Redline of D1001701-v2
Appert 2019.01.23

CALIFORNIA INSTITUTE OF TECHNOLOGY MASSACHUSETTS INSTITUTE OF TECHNOLOGY		PART NAME	
SYSTEM	SUB-SYSTEM	I/O EXPANSION CHASSIS	
	DAQ	DESIGNER	
		DRAFTER	E.BROWN
		CHECKER	
		APPROVAL	
NEXT ASSY		SIZE	c

SIZE	DWG. NO.	REV.
c	D1001701_v2	
SCALE: 1:1	PROJECTION:	SHEET 1 OF 1

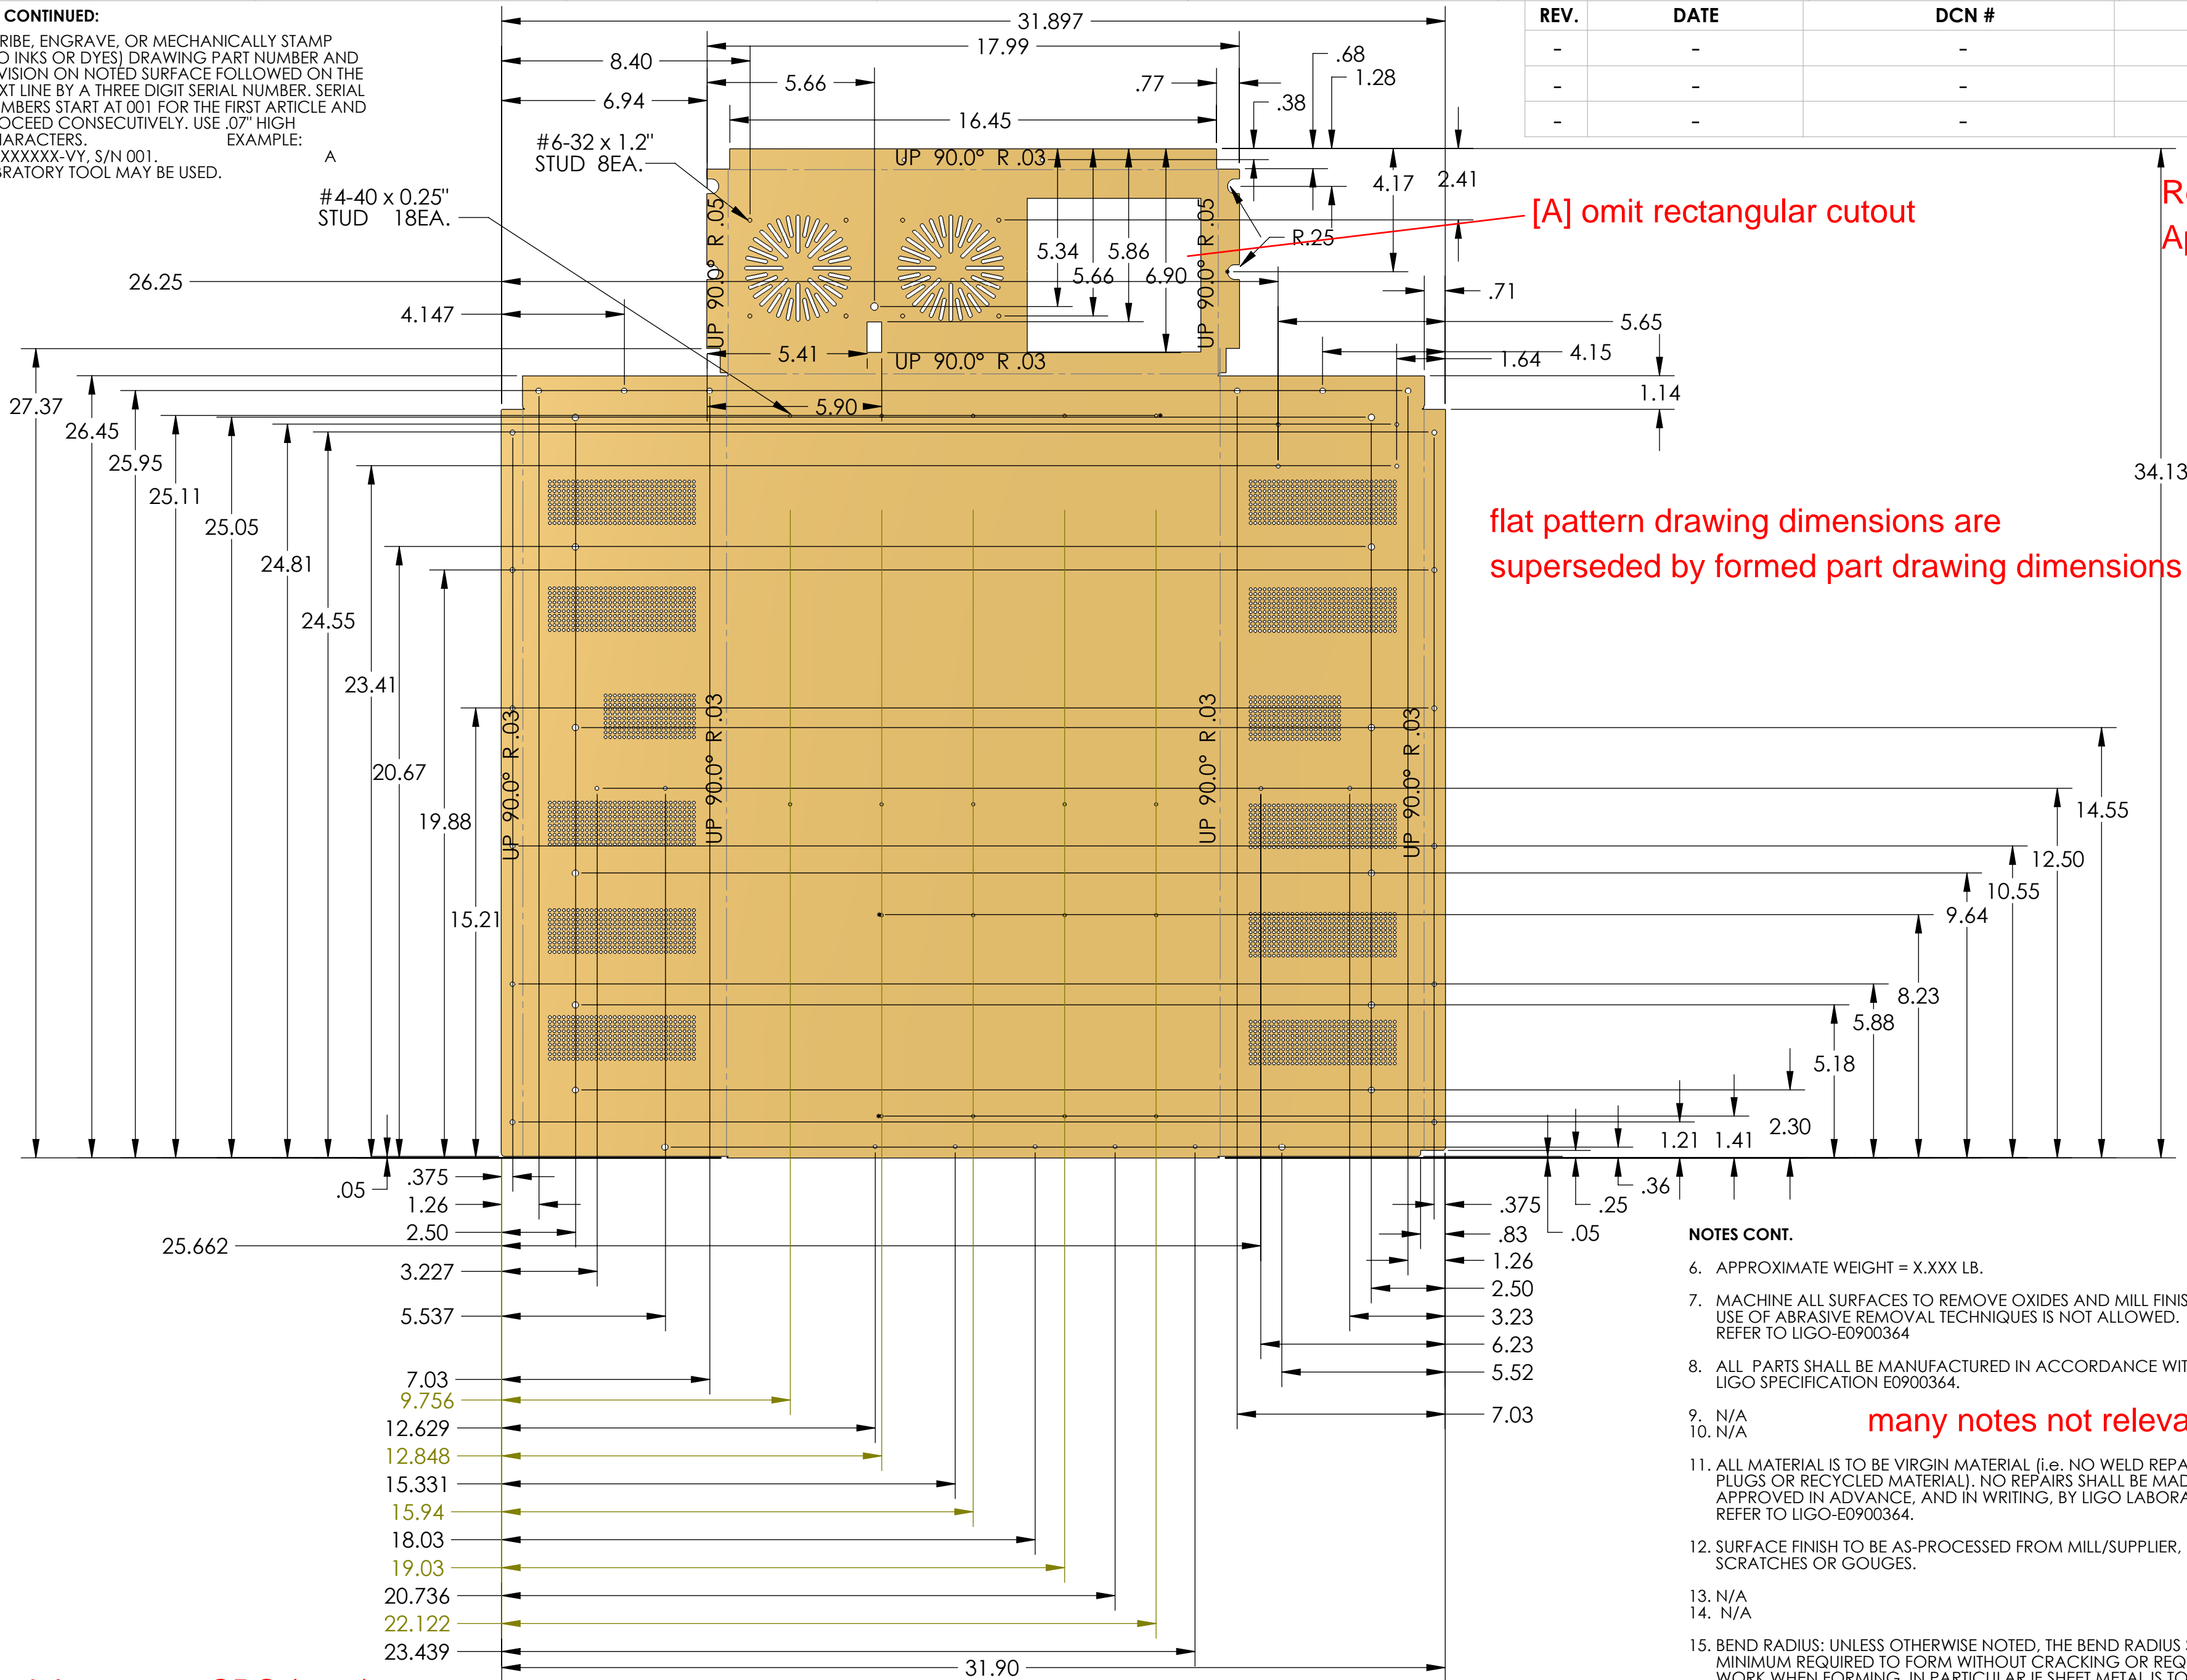
many notes not relevant

list of changes which affect part geometry:
[A] omit rectangular cutout

material: 18 gage CRS (.048)

[A]

Redline of v2
Appert 2019.01.23

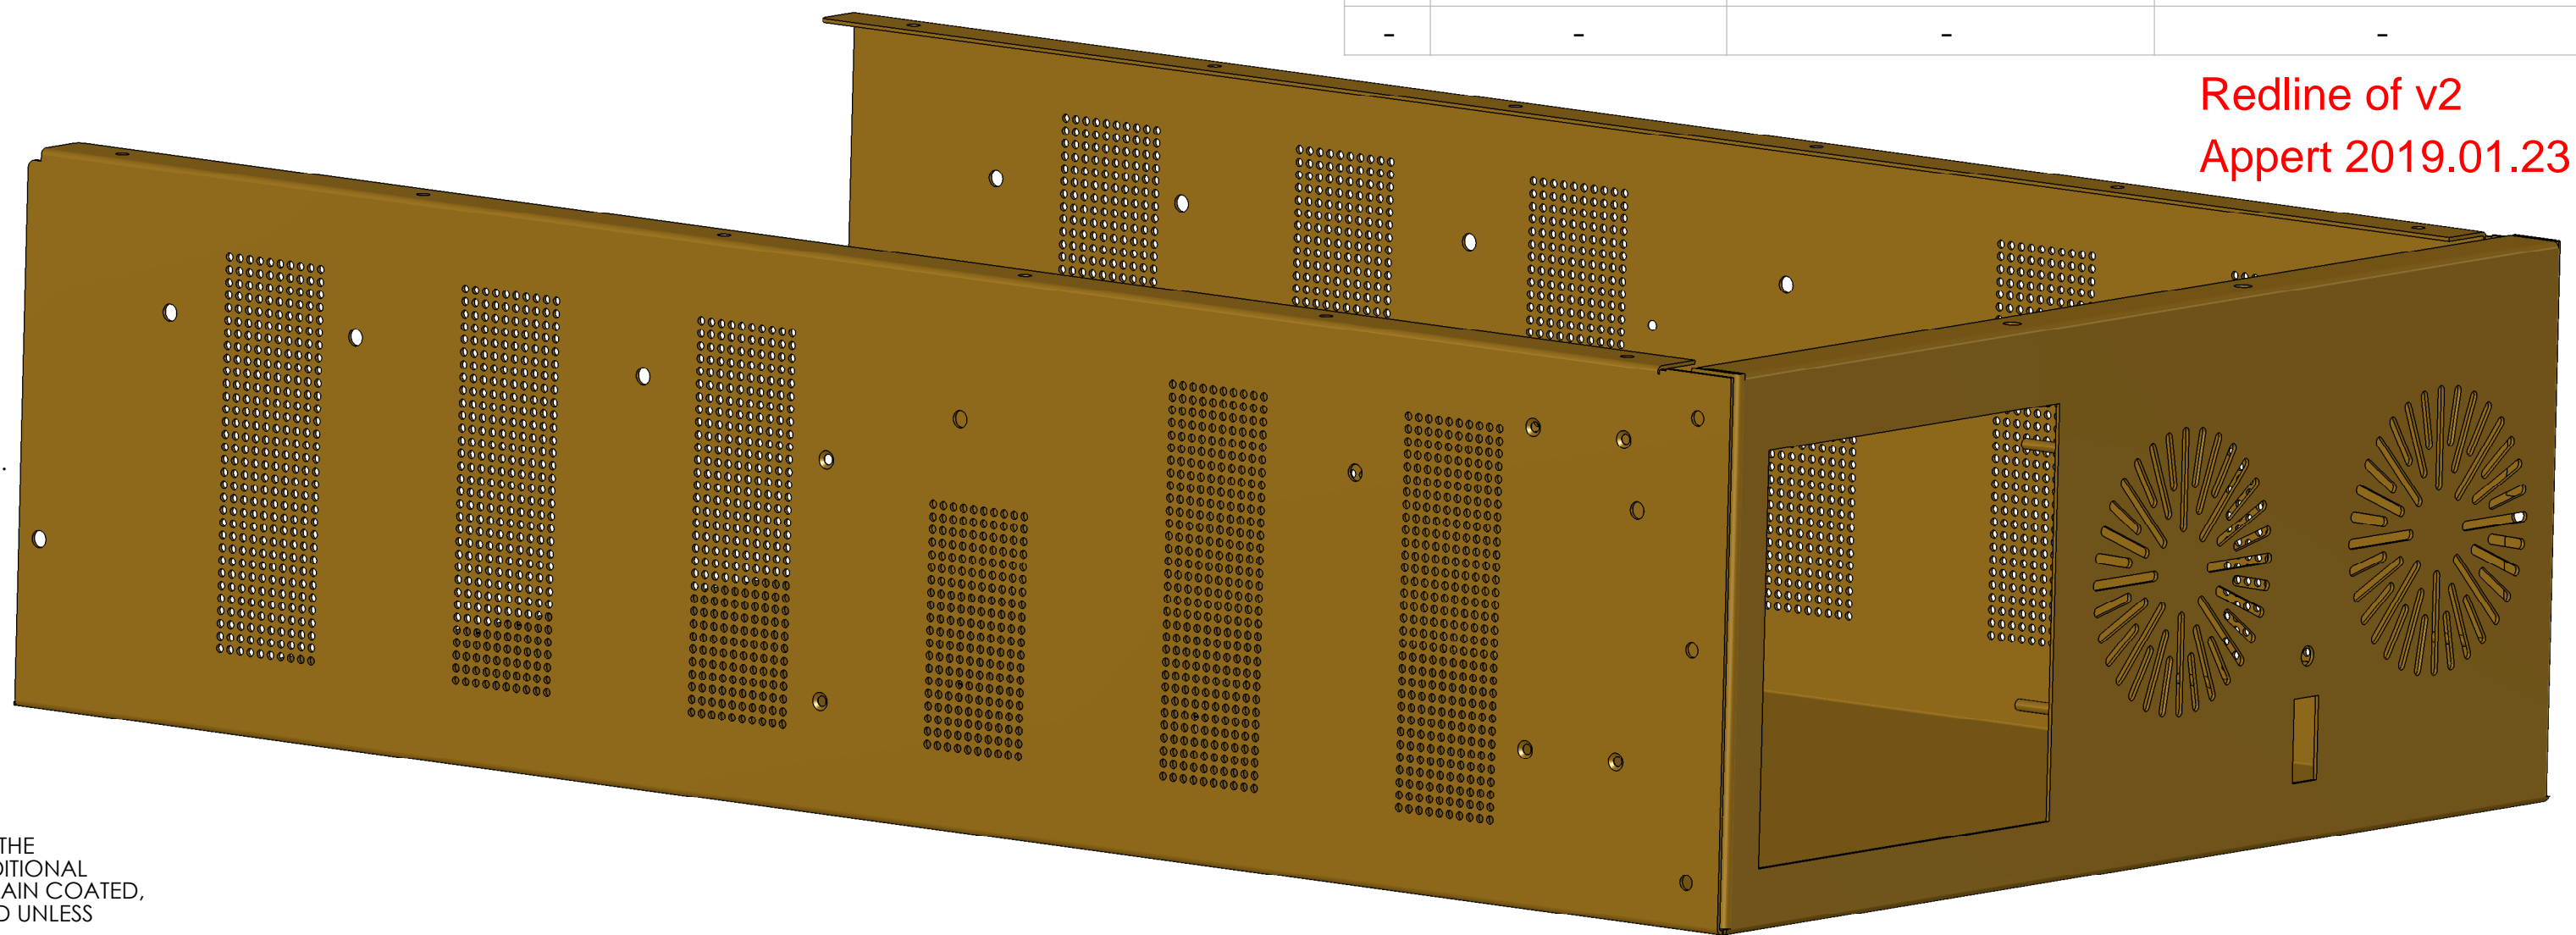
[A] omit rectangular cutout

flat pattern drawing dimensions are superseded by formed part drawing dimensions

material: 18 gage CRS (.048)

many notes not relevant

Redline of v2
Appert 2019.01.23

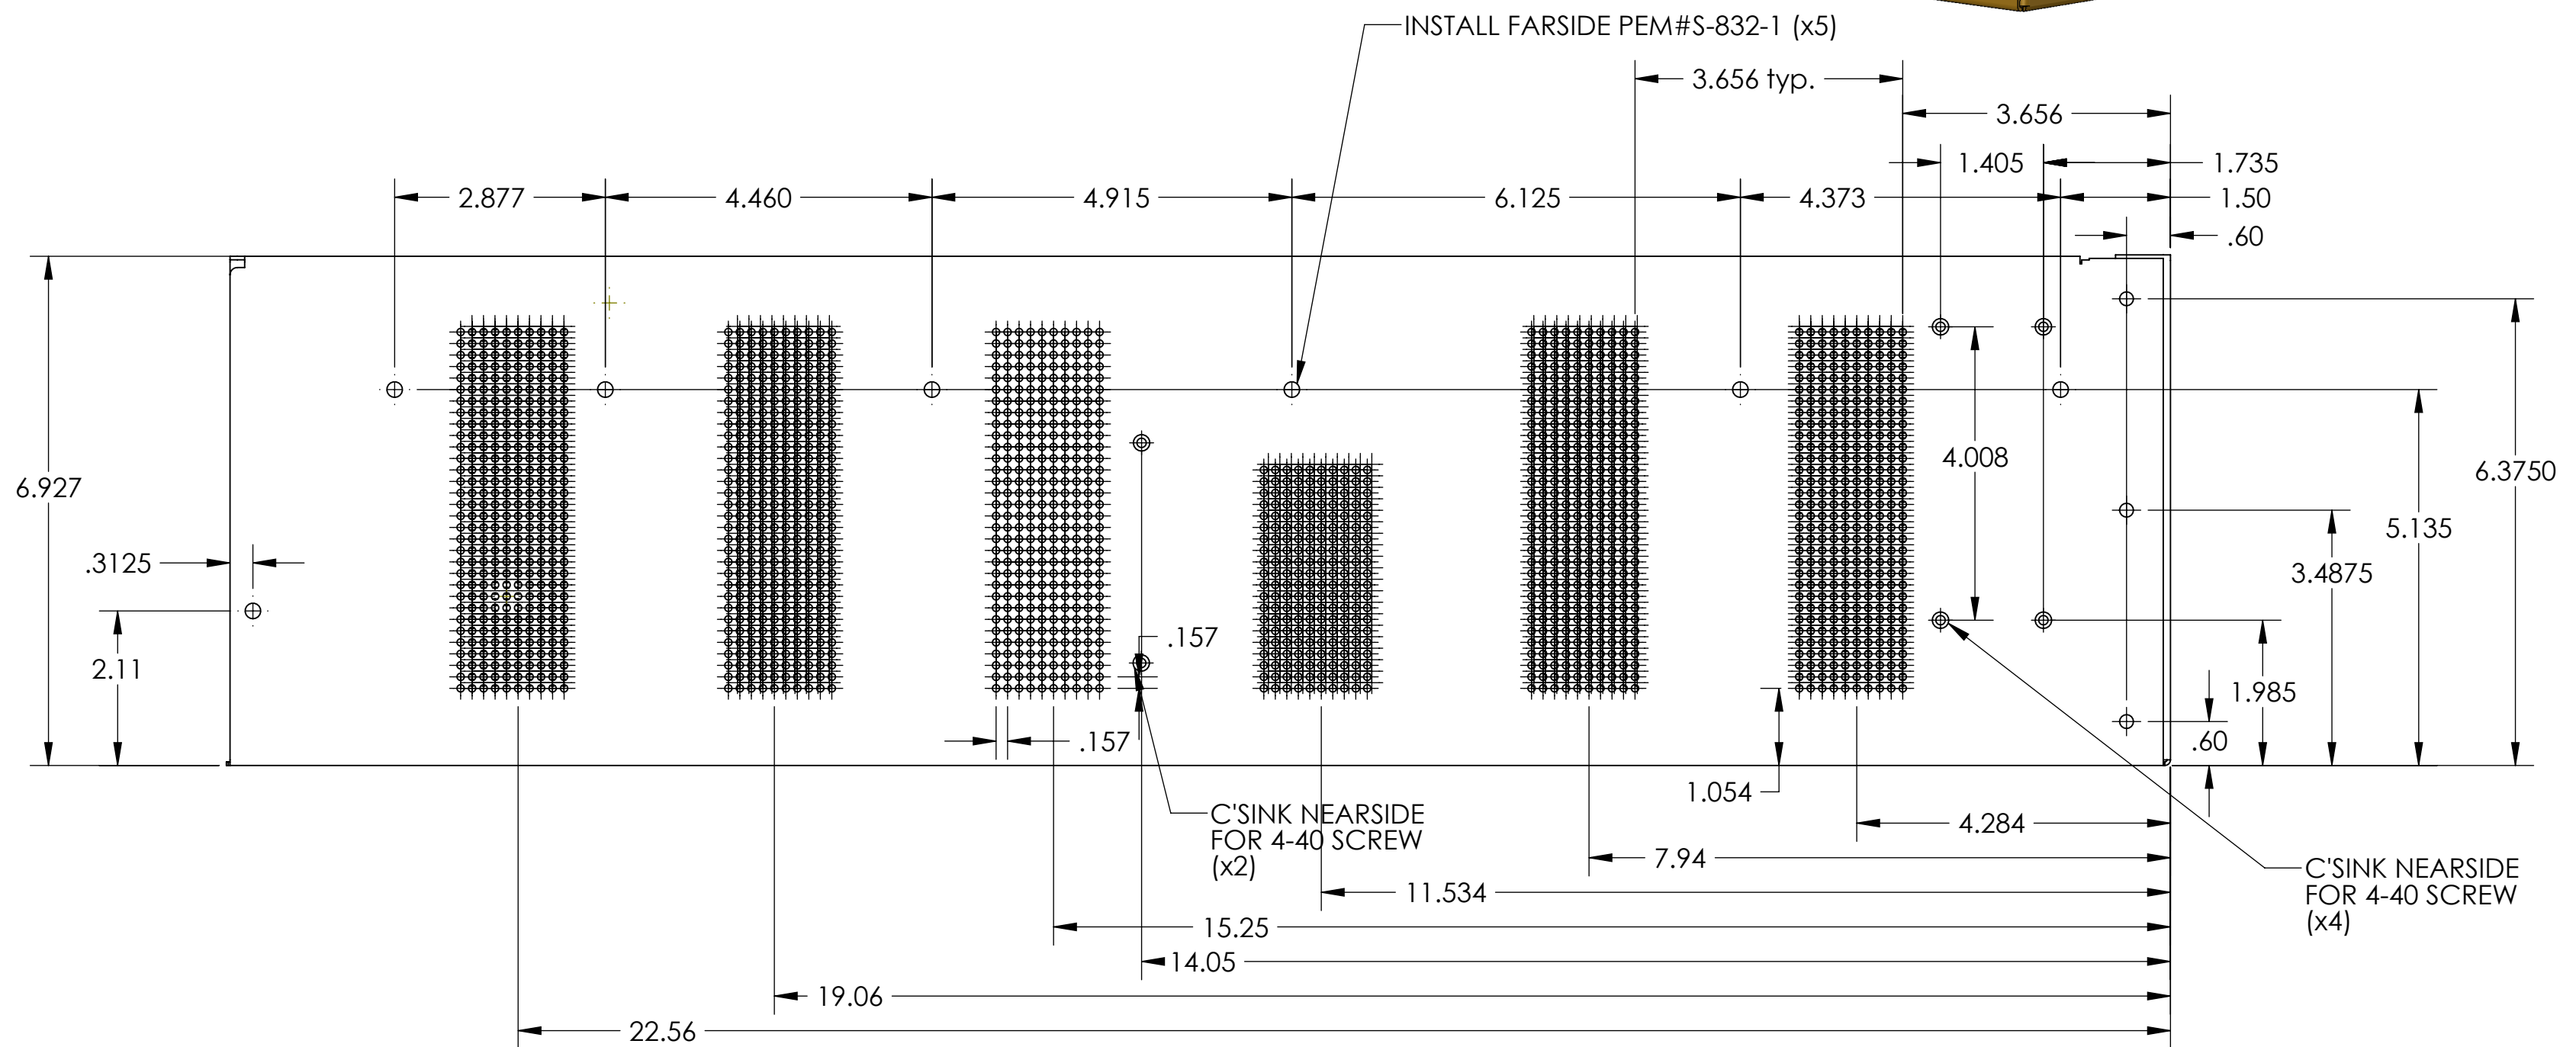
many notes not relevant

material: 18 gage CRS (.048)

Redline of v2
Appert 2019.01.23

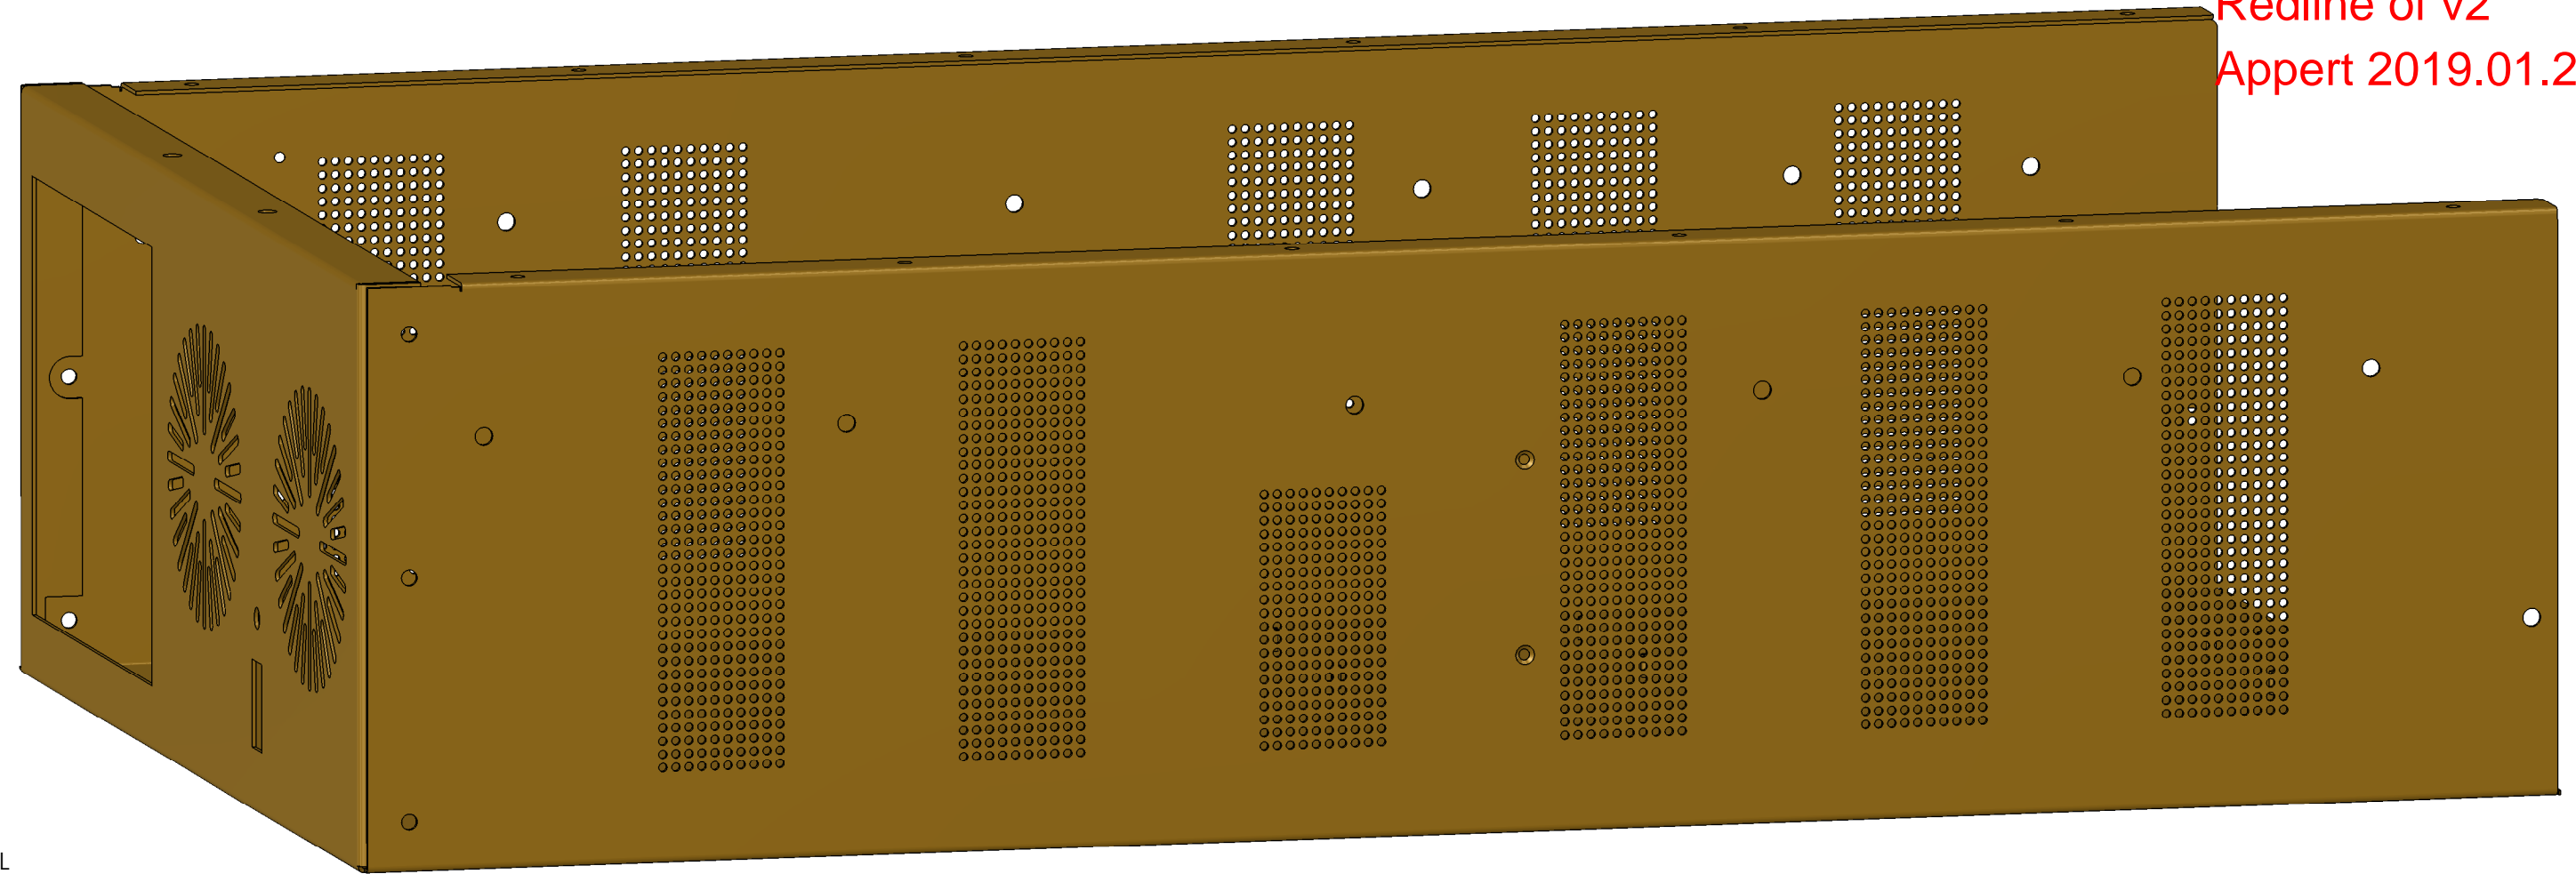
many notes not relevant

material: 18 gage CRS (.048)
